**SUPERELEVATION
BANKING DIAGRAM
SHEET #2**

DESIGNED BY	BCE/PJM	DATE	7-02
DRAWN BY	C.E.A., INC.	DATE	7-02
DESIGN FILE NO.	/pave/98b090/pb090.dgn		
PRF FILE	pb090bd2.1	DATE PLOTTED	09-MAY-2008
PROJ. NAME	MARSHFIELD - CABOT		
PROJ. NO.	NH 2104(1)S		
SHEET	28	OF	60 SHEETS

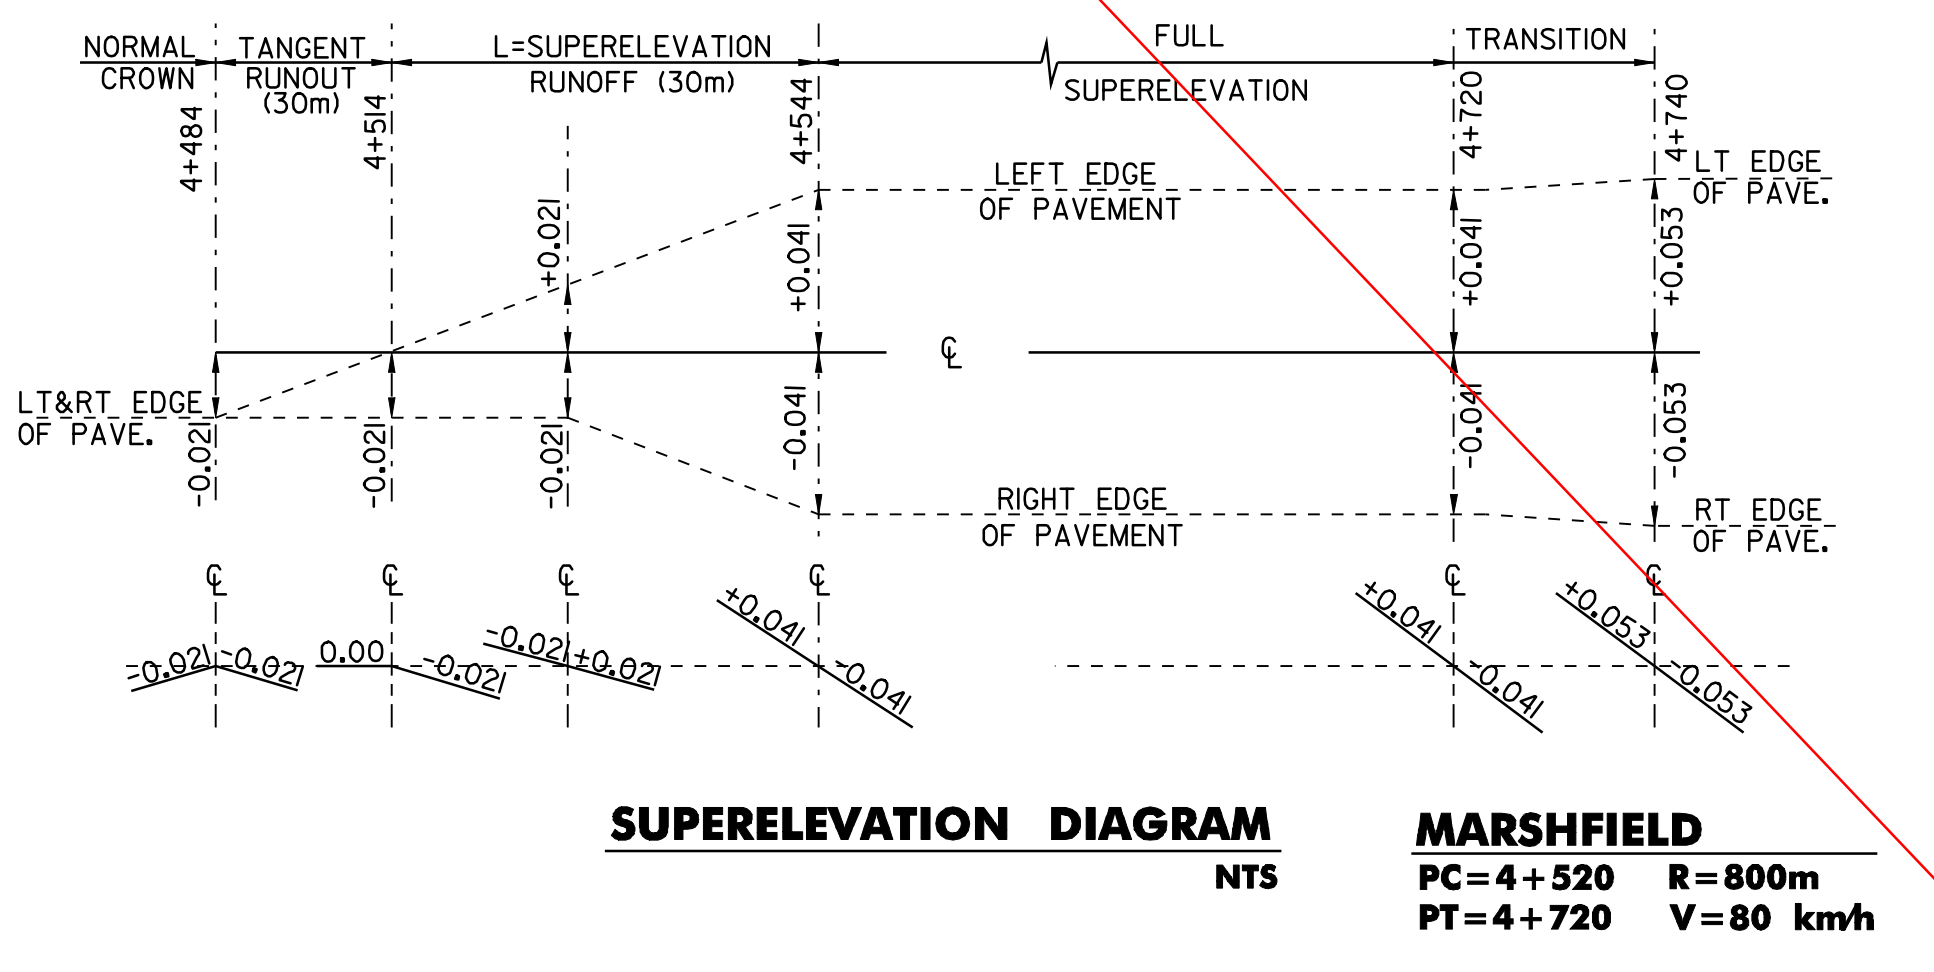
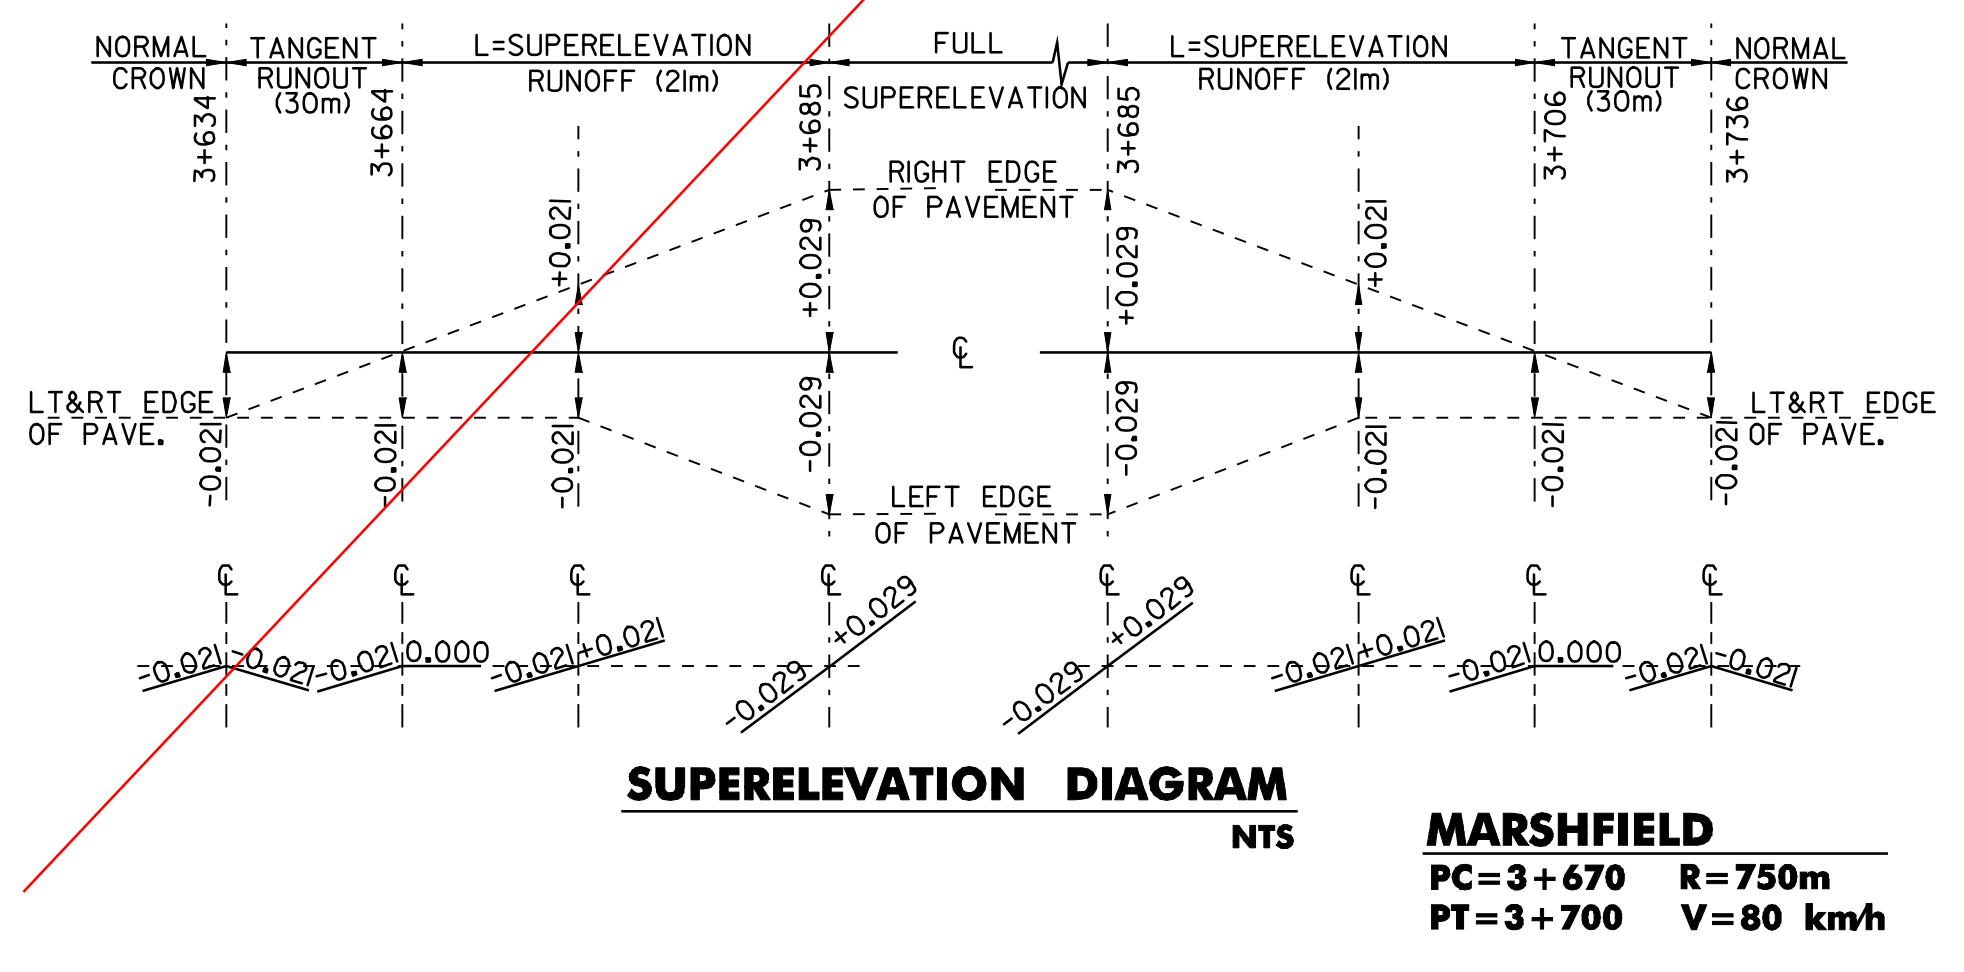
SEE HAND DRAWN REVISED BANKING DIAGRAMS

NOTE:
THE CONTRACTOR IS RESPONSIBLE FOR THE ENGINEERING WORK
REQUIRED TO LAYOUT AND MAINTAIN THE CROSS SLOPES IN THE
REGRADEING OF THE RECLAIMED AREAS.
